COMPOSITE PLAN (FOR REFERENCE ONLY)

DRAWING TITLE
PROPOSED DEMOLITION PLAN

DRAWING TITLE
EXISTING SITE PLAN (FOR REFER. ONLY)

DRAWING TITLE
PROPOSED DIMENSIONED SITE PLAN

1 A101 PROPOSED SITE PLAN SCALE: 1" = 10'-0"

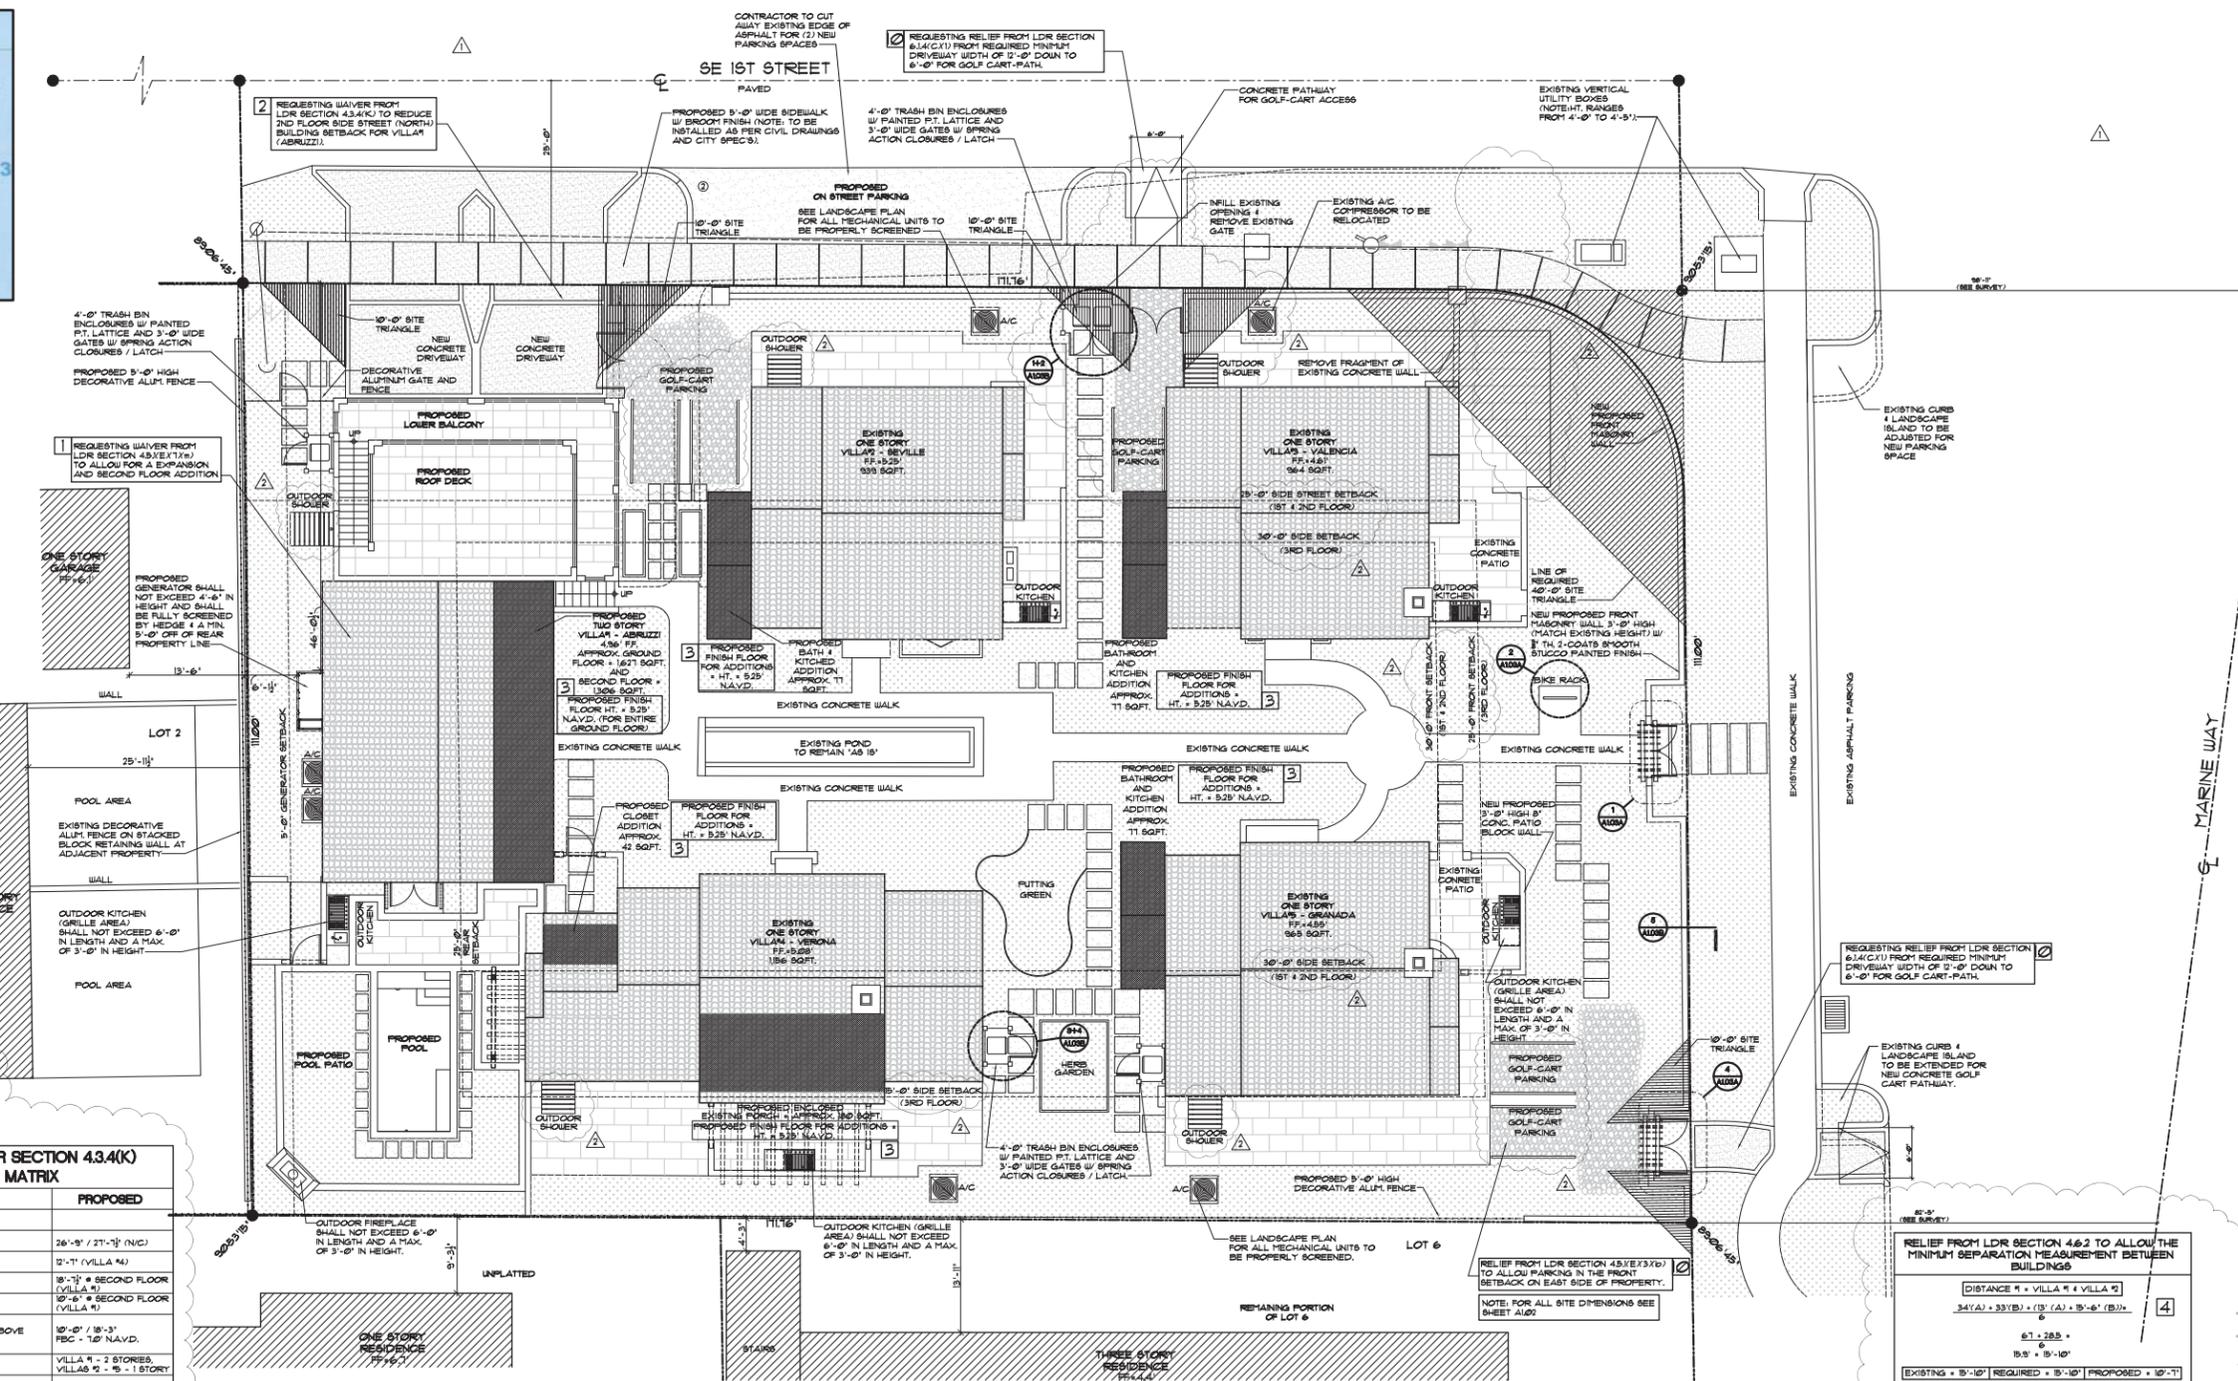
- REVISED 6/30/19 AS PER CITY COMMENTS
- PROVIDED SITE TRIANGLES
- PROVIDED TRASH BIN ENCLOSURES
- ADJUSTED DRIVEWAYS/GOLF CART PATHS.
- SHARDED TRELLIS STRUCTURES.
- ADDED EXISTING CENTER LINE OF ROADS AND ADJACENT PROPERTIES.
- ADDED ALL REQUESTED VARIANCES.
- REVISED 3/6/19 AS PER CITY COMMENTS
- REMOVED PROPOSED TRELLIS & OUTDOOR SHOWER STRUCTURES.
- ADJUSTED SITE TRIANGLE.
- UPDATED SETBACKS.
- UPDATED CALCULATIONS.

1 PROPOSED DIMENSIONED SITE PLAN
 SCALE: 1" = 10'-0"

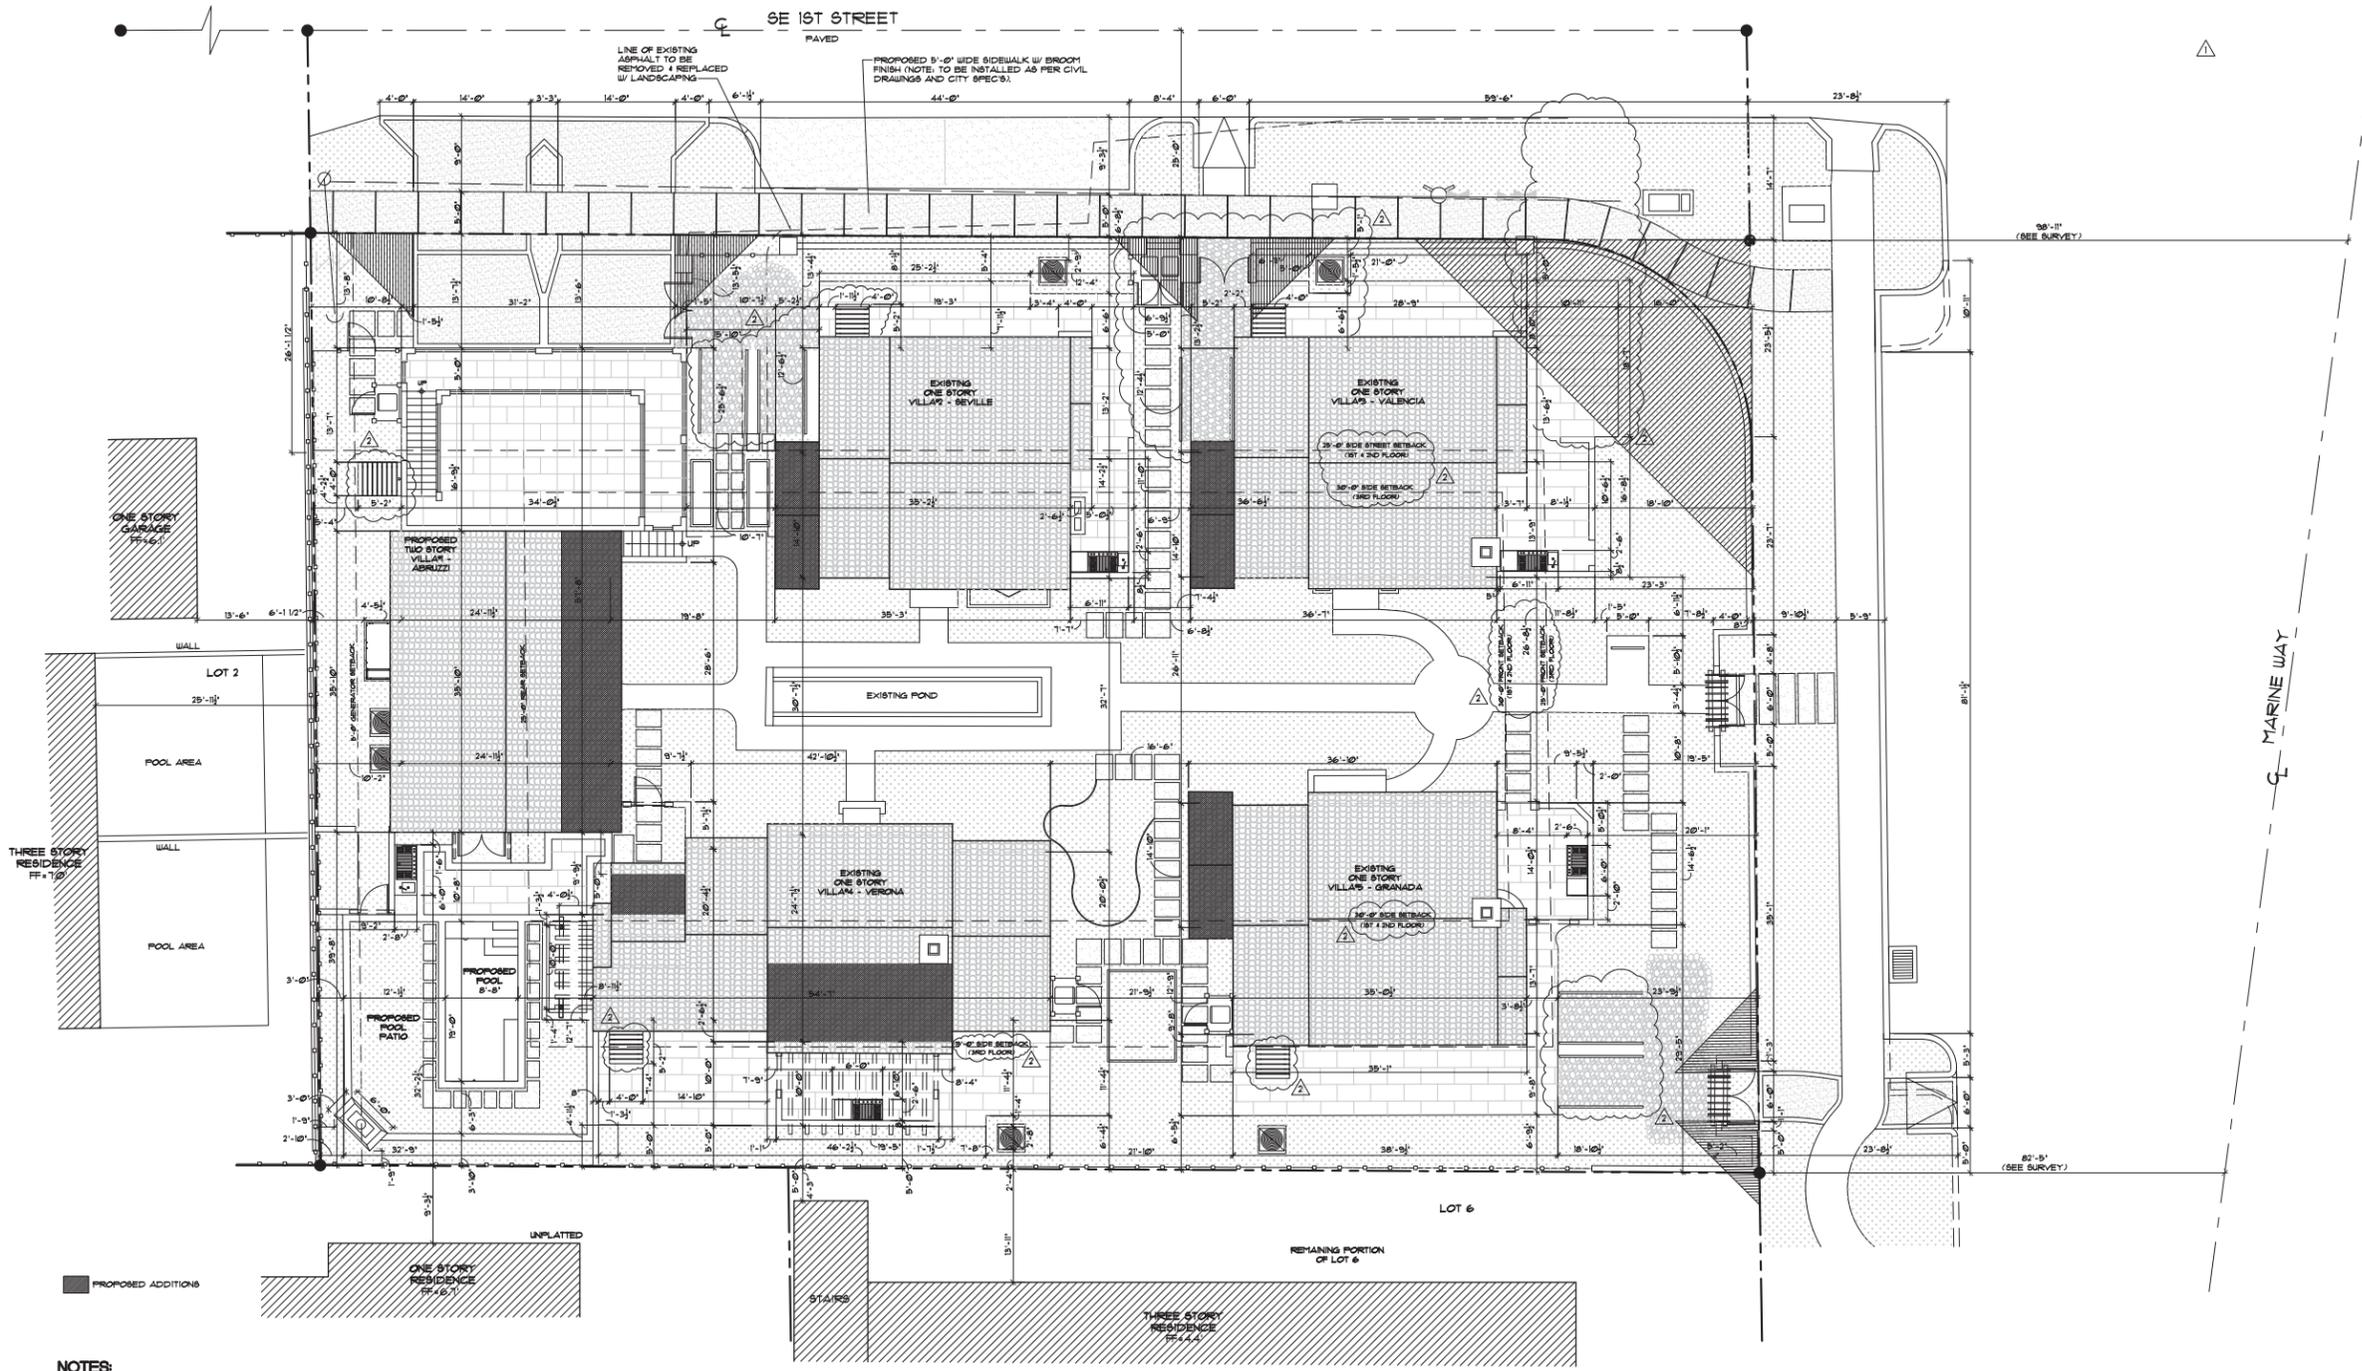
- REVISIONS
- △ REVISED 6/30/18 AS PER CITY COMMENTS:
 1. PROVIDED SITE TRIANGLES.
 2. PROVIDED TRASH BINS/ENCLOSURES.
 3. ADJUSTED DRIVEWAY'S/GOLF CART PATHS.
 4. PROVIDED DIMENSIONS TO ADJACENT CENTER LINES OF ROADS.
 - △ REVISED 9/16/18 AS PER CITY COMMENTS:
 1. REMOVED PROPOSED TRELLISES & OUTDOOR SHOWER STRUCTURES.
 2. ADJUSTED SITE TRIANGLE.
 3. UPDATED SETBACKS.

EXISTING ARCHITECTURAL CONTEXT SITE PLAN

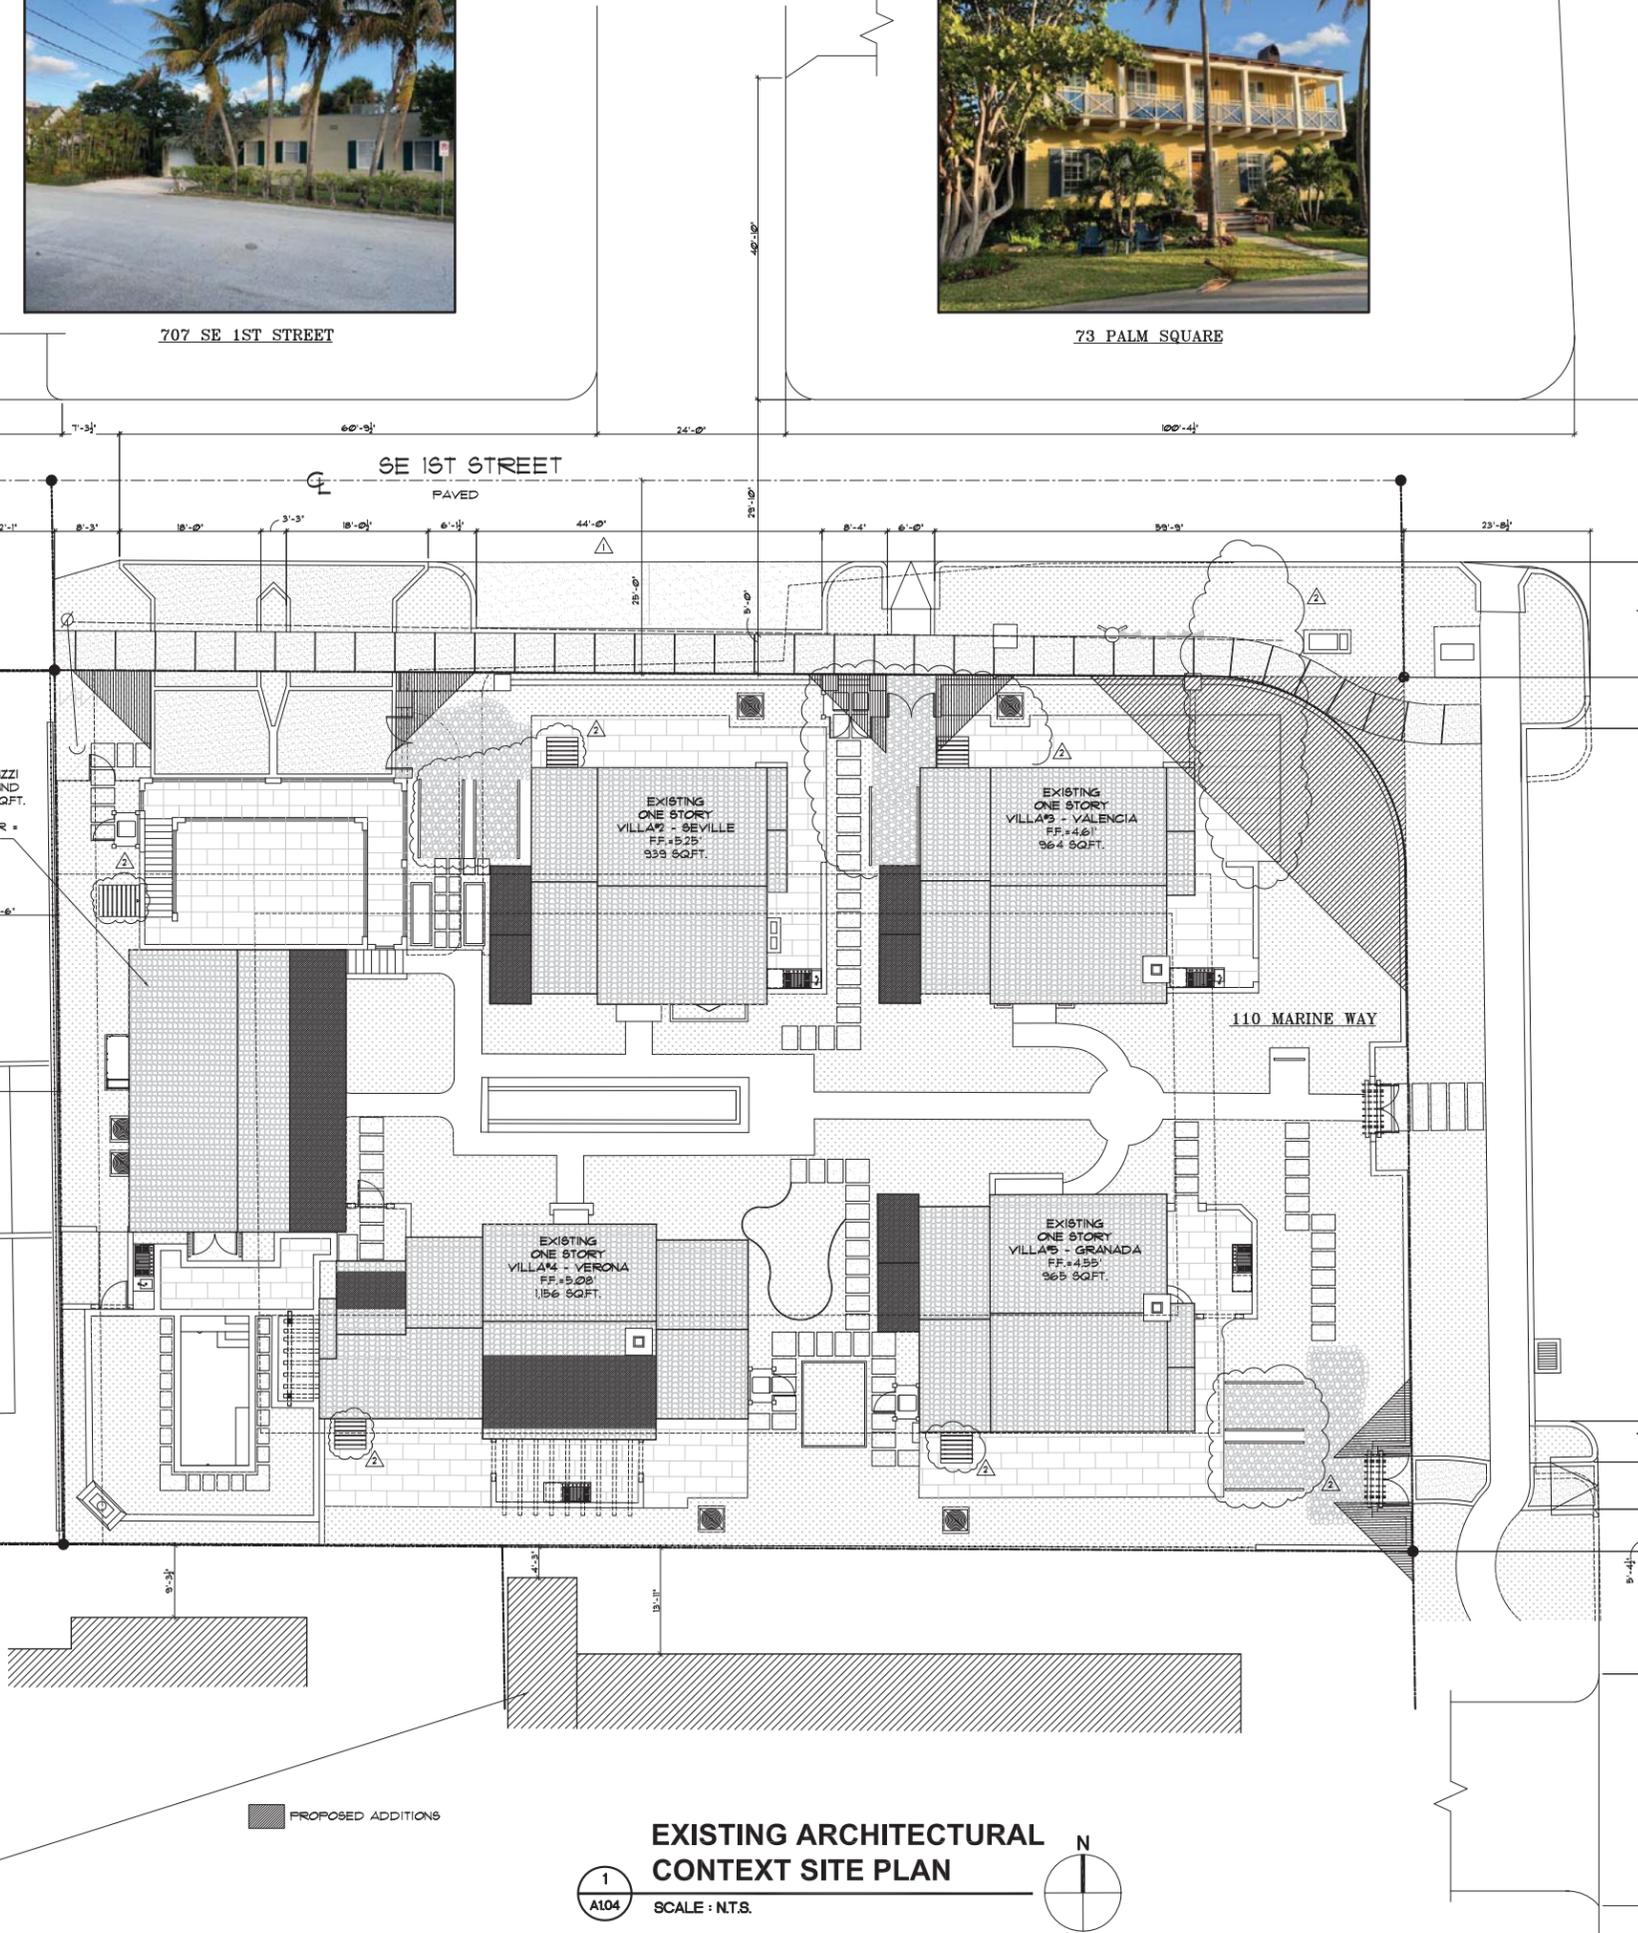
- REVISOR: 6-30-19 AS PER CITY COMMENTS:
 1. ADDED DIMENSIONS TO CENTER LINE OF ADJACENT ROAD.
- REVISOR: 9-16-19 AS PER CITY COMMENTS:
 1. REMOVED PROPOSED TRELLISES & OUTDOOR SHOWER STRUCTURES.
 2. ADJUSTED SITE TRIANGLE.
 3. UPDATED SETBACKS.
